Access Compliance Report

Public Rights-of-Way

| Intersection ID: 12310 | Main Street: WEYLAND_AV | Cross Street: GREENLAND_AV | Location: NW |
| ADA ID: 87055CEC6A6D | Ramp Type: Perp | Initial Pass/Fail: Fail | Overall Compliance: No |

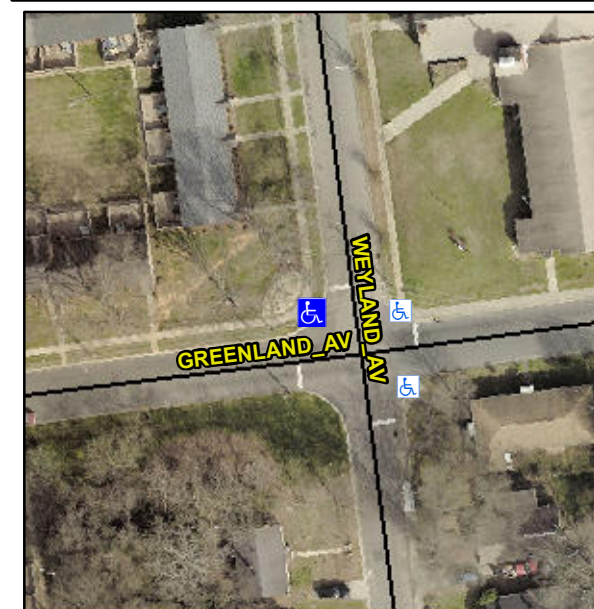
Not Found, R304.5.1, R304.2.2, R304.5.3

| Compliance | Description | Data | Compliance | Description | Data |
|------------|-----------------------|------|------------|-----------------------------|------|
| N/A | Ramp Length (in) | 78.0 | No | Ramp Slope (%) | 8.8 |
| No | Ramp Width (in) | 39.0 | No | Ramp XSlope (%) | 5.2 |

Remove & Replace Entire Ramp.
